**Economic and Social Council**Distr.: General
25 September 2012

World Forum for Harmonization of Vehicle Regulations**Working Party on Passive Safety****Fifty-second session**

Global technical regulation No. 9 (Pedestrian safety) – Proposal for Amendment 2**Proposal for Amendment 2 to global technical regulation
No. 9 (Pedestrian safety)****Submitted by the expert from the European Commission***

Insert new Figures 6A to 6C, to read:

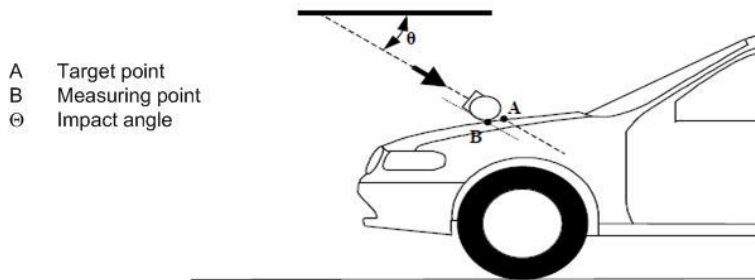
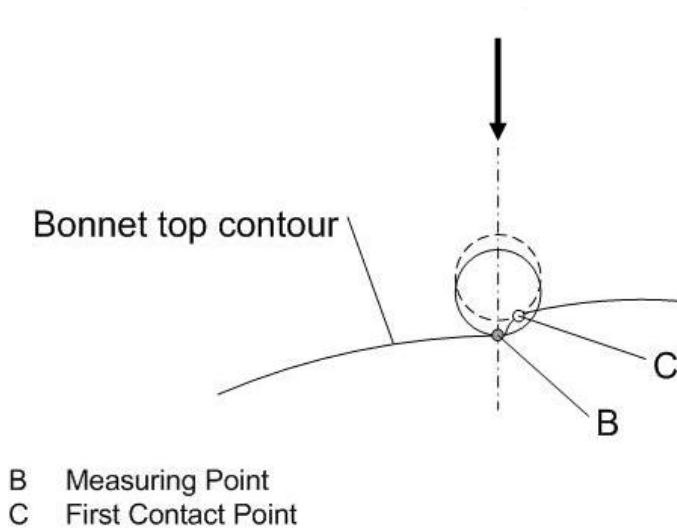
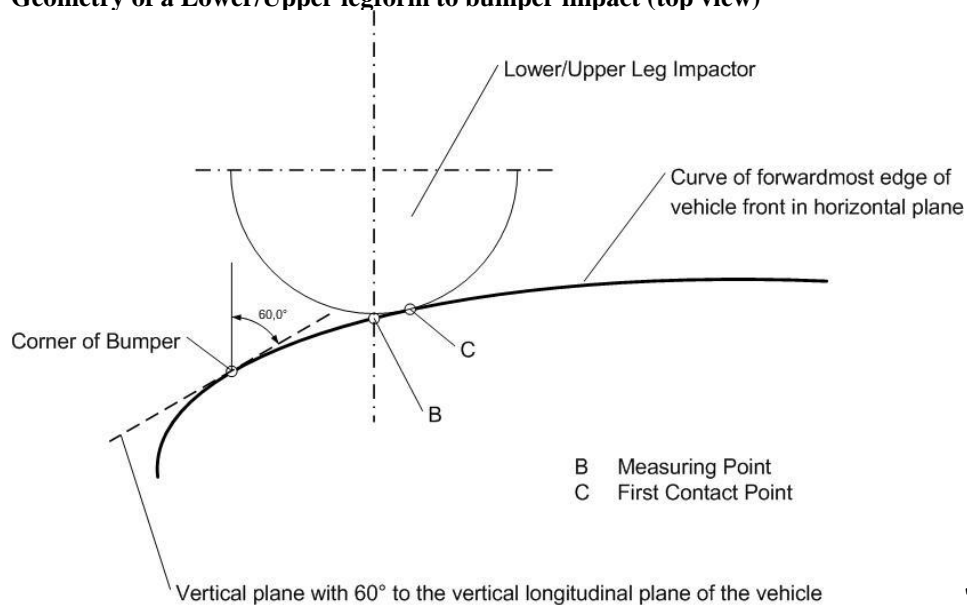
Figure 6, shall be deleted

Measuring and target point in the vertical longitudinal plane through the center of the impactor (see paragraphs 3.30.1. and 3.25.)²

Measuring and first contact point (see paragraphs 3.30.1. and 3.19.)²
(schematic front view)

² Remark: due to the spatial geometry of the bonnet top, the first contact point C does, in most cases, not lie in the same vertical longitudinal or transverse plane which contains measuring point B.

Figure 6C
Measuring and first contact point (see paragraphs 3.30.2. and 3.19.)
Geometry of a Lower/Upper legform to bumper impact (top view)

"Figure 11

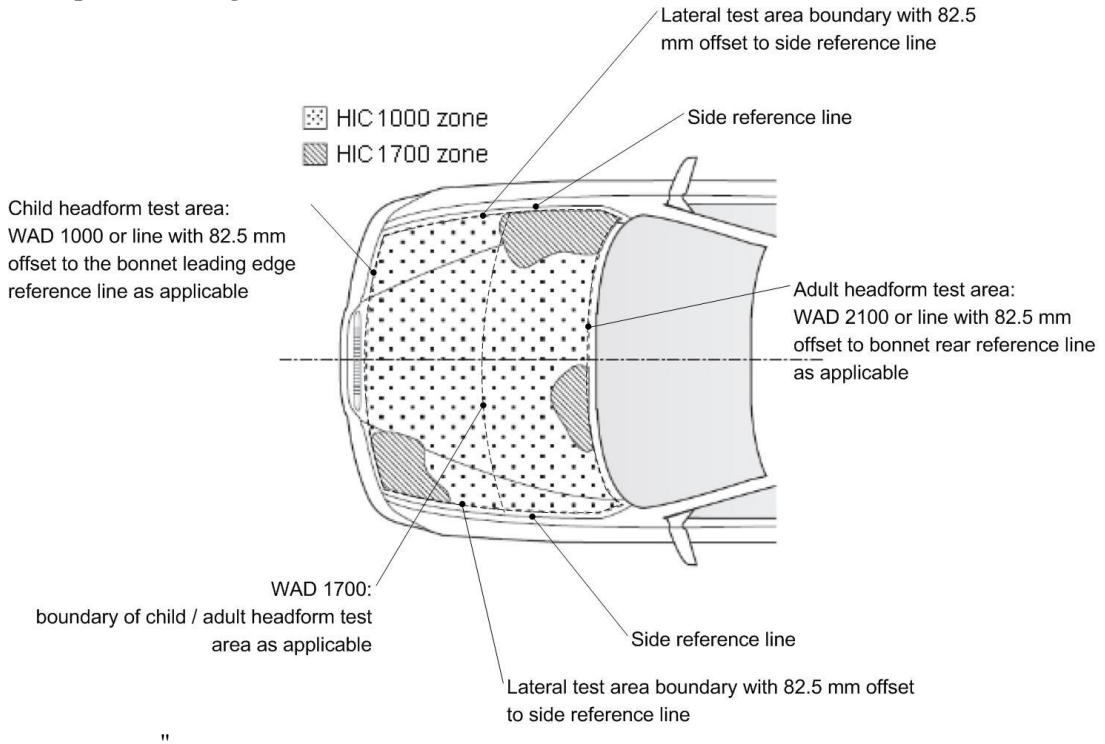
Figure 11(former), shall be deleted

Example of marking of HIC1000 zone and HIC1700 zone
